SUBJECT: NINE MILE POINT NUCLEAR STATION UNITS 1 AND 2 – STAFF  
ASSESSMENT OF RESPONSE TO 10 CFR 50.54(f) INFORMATION REQUEST  
– FLOOD-CAUSING MECHANISM REEVALUATION (TAC NOS. MF1104 AND  
MF1105)

STAFF ASSESSMENT BY THE OFFICE OF NUCLEAR REACTOR REGULATION

RELATED TO FLOODING HAZARD REEVALUATION REPORT

NINE MILE POINT NUCLEAR STATION UNITS 1 & 2

**Figure 3.4-1. Oswego River Watershed basin with the location of the site (red square) and dams (blue dots).**

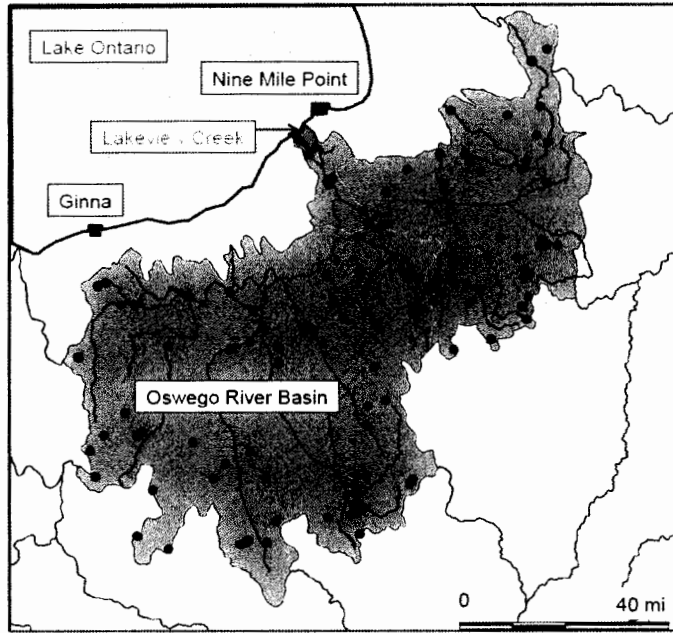
The staff performed a bounding analysis of dam failure flooding in the Oswego River basin. From the 2013 National Inventory of Dams Database maintained by USACE, the staff identified a total of 123 dams within the Oswego River basin (see Figure 3.4-1). Most of the identified dams (about 110 dams) have storage capacity less than 10,000 ac-ft (0.012 km<sup>3</sup>). The total reservoir volume of these 123 dams is approximately 2,008,600 ac-ft (2.47 km<sup>3</sup>). The staff conservatively assumed all dams fail simultaneously and discharge water into Lake Ontario without loss. With the surface area of Lake Ontario of 4.7 million acres (19,000 km<sup>2</sup>), this bounding approach results in a lake level increase of approximately 0.43 ft (0.13 m) which is higher than the licensee's estimate but well below the plant grade and the current design basis flood height.

Figure 4.0-1. Time Series of Water Surface Elevation at Element 8156 Unit 1 – 6-hour PMP (from the FHR Figure 2.1-14).

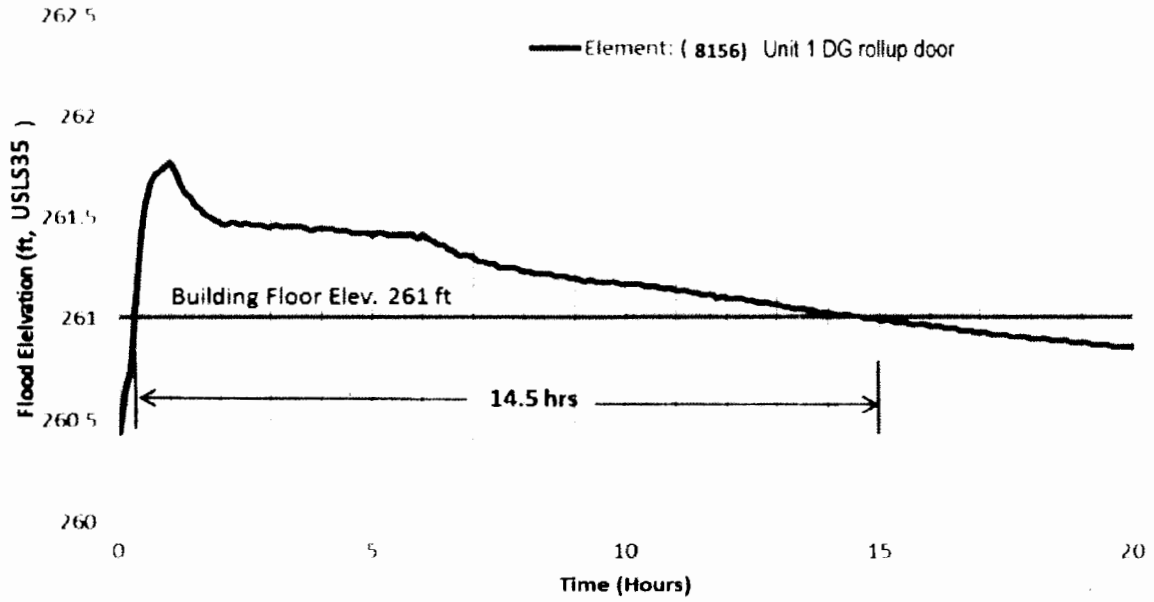
Staff agreed with the licensee's conclusion that the 72-hour PMP event results in the highest water surface elevation and longest period of inundation. However, as described in Section 3.2, the staff noted that PMP events shorter than 72-hour PMP result in (potentially significantly) shorter warning time and likewise results in a flood above the elevation of openings to plant structures. For example, a 6-hour PMP event results in an estimated flood warning time of less than one hour with a flood inundation duration of 14.5 hours above elevation 261 ft (79.55 m) (see Figure 4.0-1). Therefore, the staff determined that, as part of the Integrated Assessment Report, the licensee should evaluate the total plant response for a range of rainfall durations associated with the LIP hazard events (e.g., 1-, 6-, 12-, 24-, 48, 72-hour PMPs) to determine the controlling scenario(s) (see NRC, 2012c). This should include a sensitivity analysis to identify potentially limiting scenarios with respect to plant response when considering flood height, relevant associated effects, and flood event duration parameters. This is Integrated Assessment Action Item No. 2. Flood elevation duration parameters are provided for the 6-hour and 72-hour events in Table 4.0-1.
